**ADDENDUM 01**

Addendum #	01	Date Issued	03/21/2025
Project Name Job #	SWN 0509, Waneta Hall Renovate Restrooms	OSE #	R0325--15X
		EAPC #	20256780
Bid Date Time	April 3, 2025		3:30pm

PROJECT DESCRIPTION
SWN 0509, WANETA HALL RENOVATE RESTROOMS (OSE# R0325--15X)

1 FIRST FLOOR LOBBY / STUDENT SPACE LIGHTING PLAN
 E304 1/8" = 1'-0"

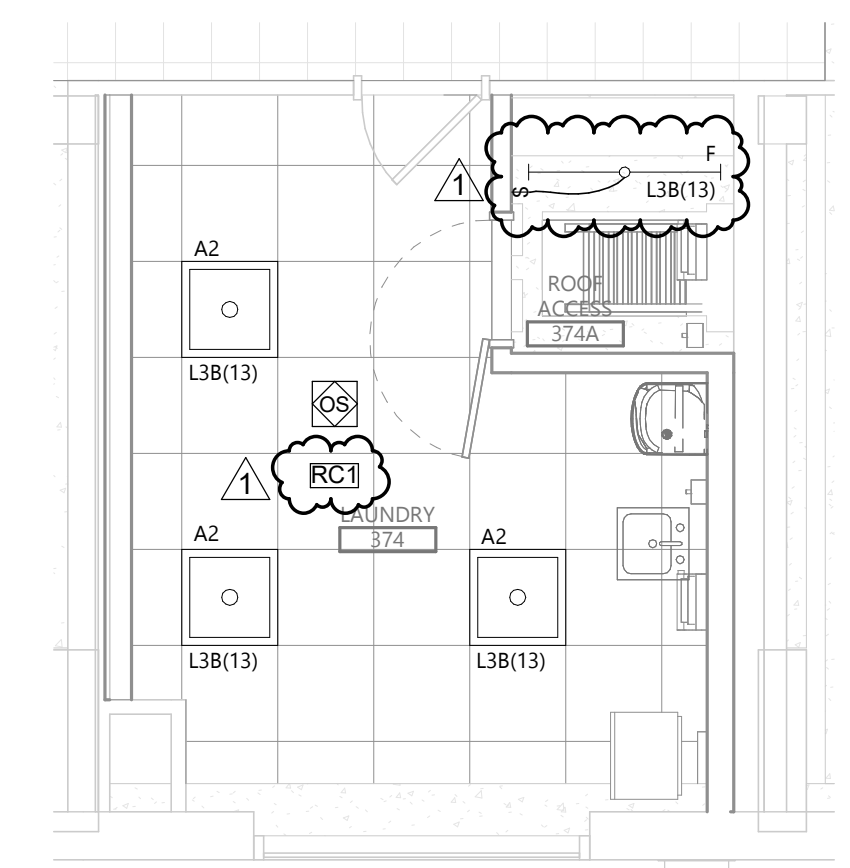
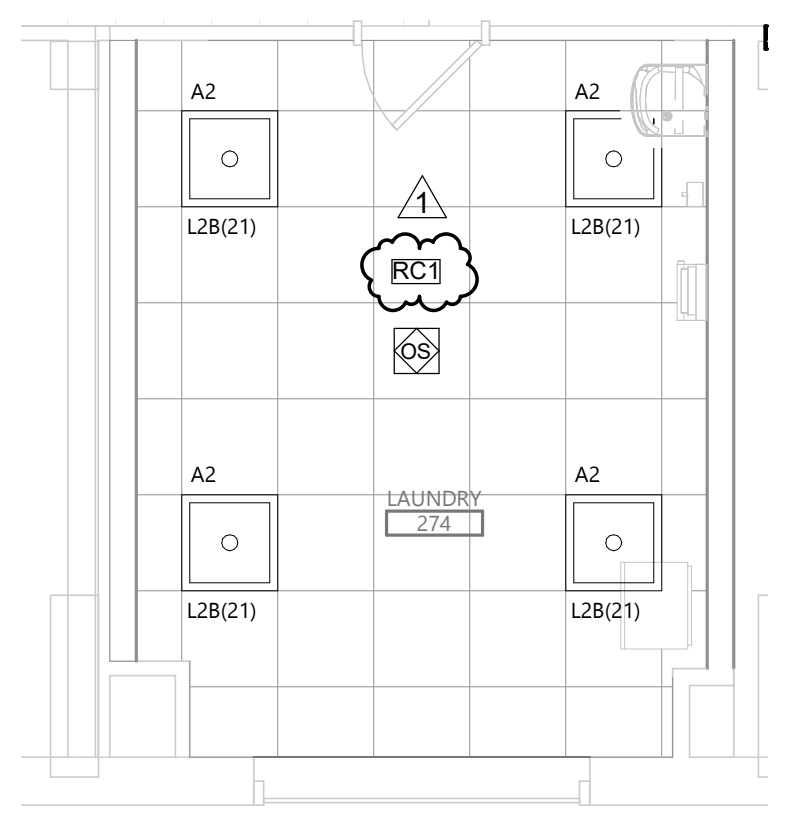
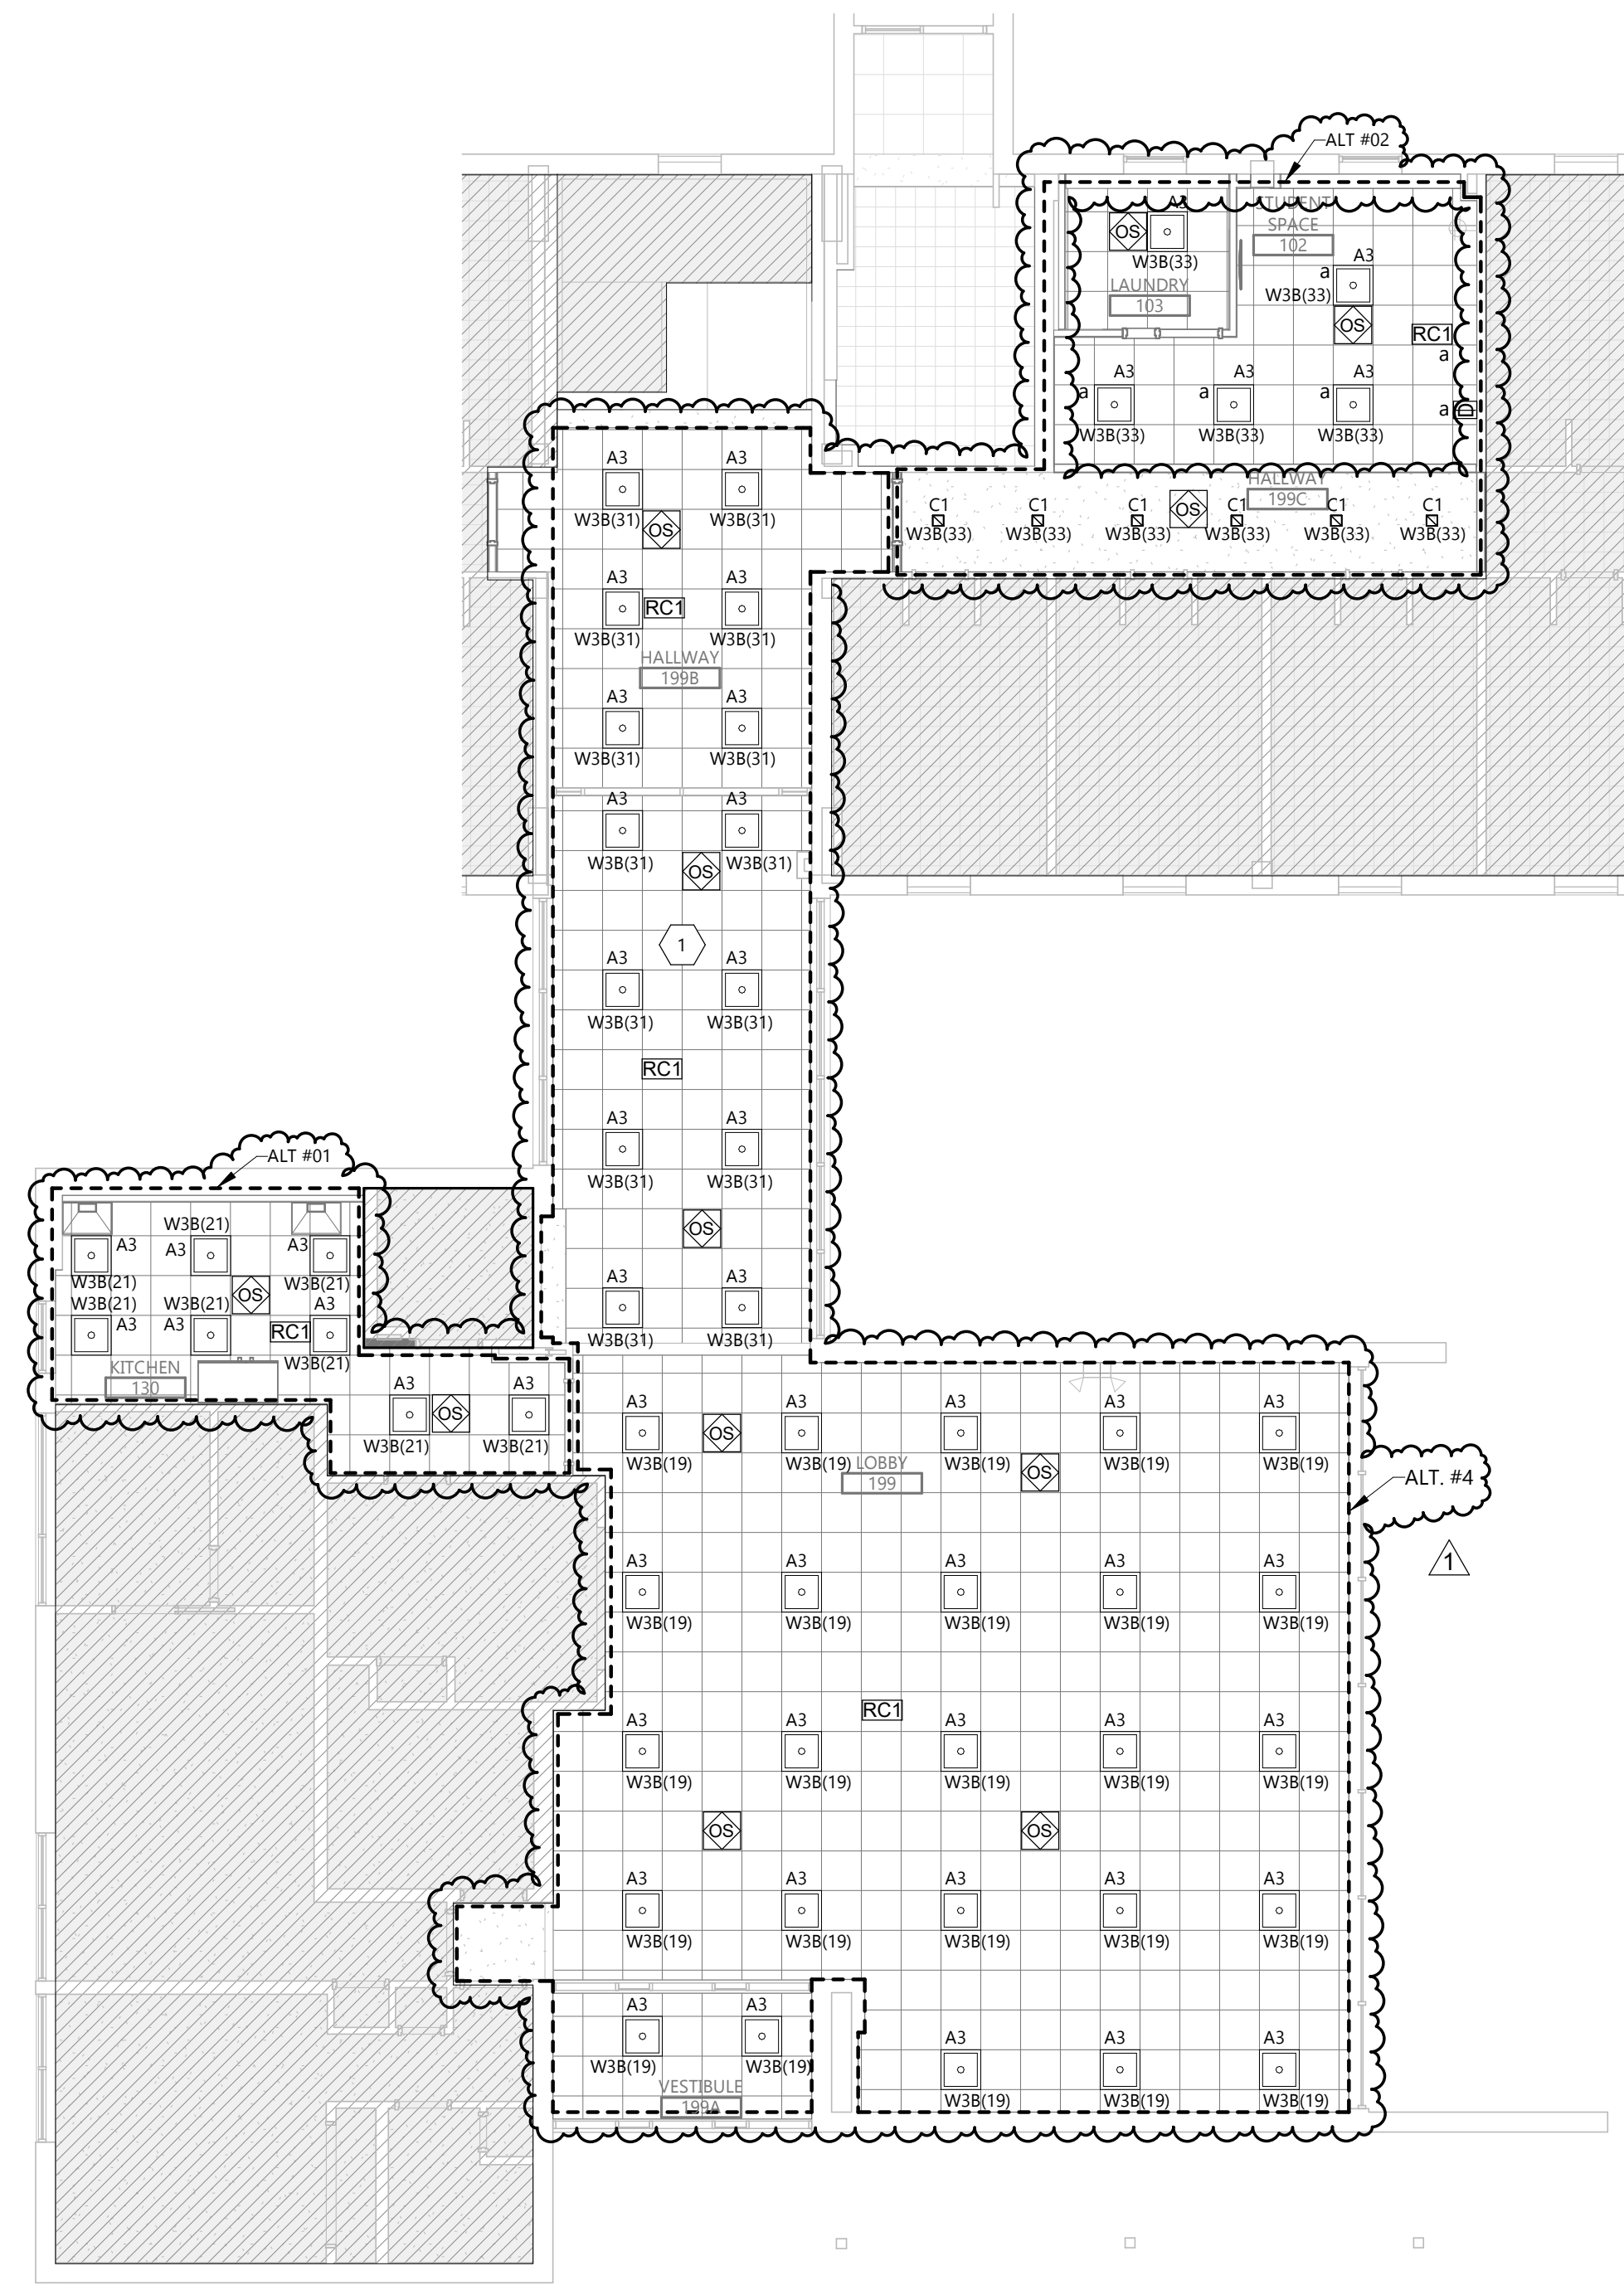
E303	ADD clarification on lighting types and occupancy sensors.
E304	CLARIFIATION on alternates.
E801	REVISIONS to motor and equipment schedules for circuiting.
E802	REVISIONS to schedules.
E901	REVISIONS to schedules.
E902	REVISIONS to schedules.
